10-Clutch Drum

GM Powerglide[®]

28756-01

Current 10-Clutch Parts

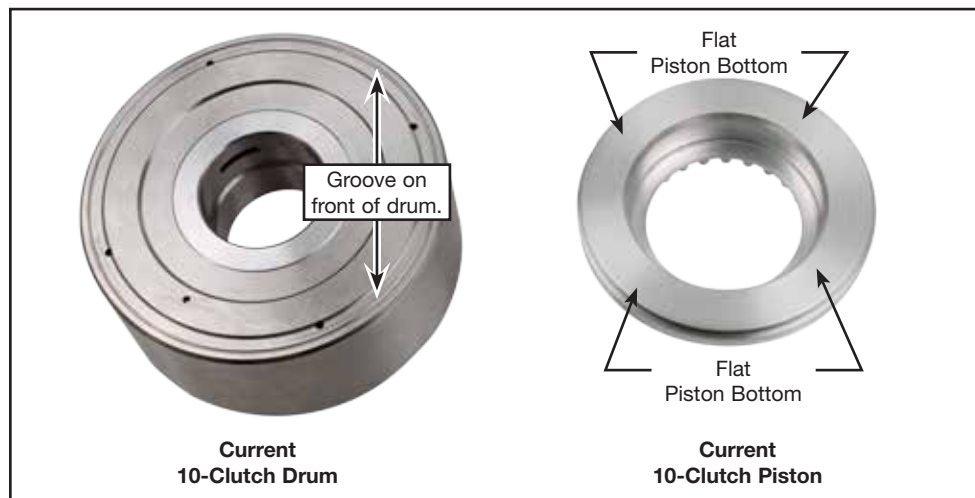
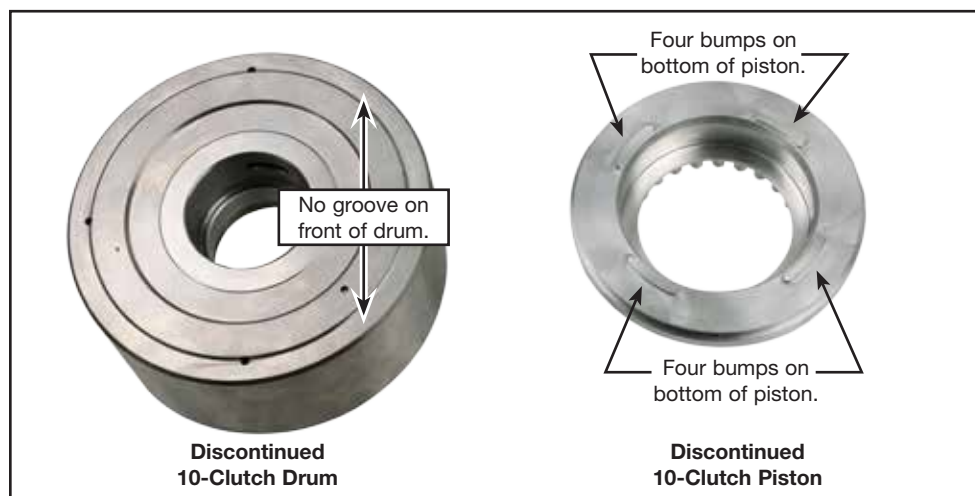
Sonnax 10-clutch drum **28756-01** features a piston bore that is .060" deeper for greater piston travel than was available from 10-clutch drums **28755-01** (discontinued). This discontinued drum was specifically for use with Sonnax 10-clutch piston **28765-04** (also discontinued).

Sonnax 10-clutch pistons and drums should **ONLY** be used as matched parts. Use the images below to properly identify your parts.
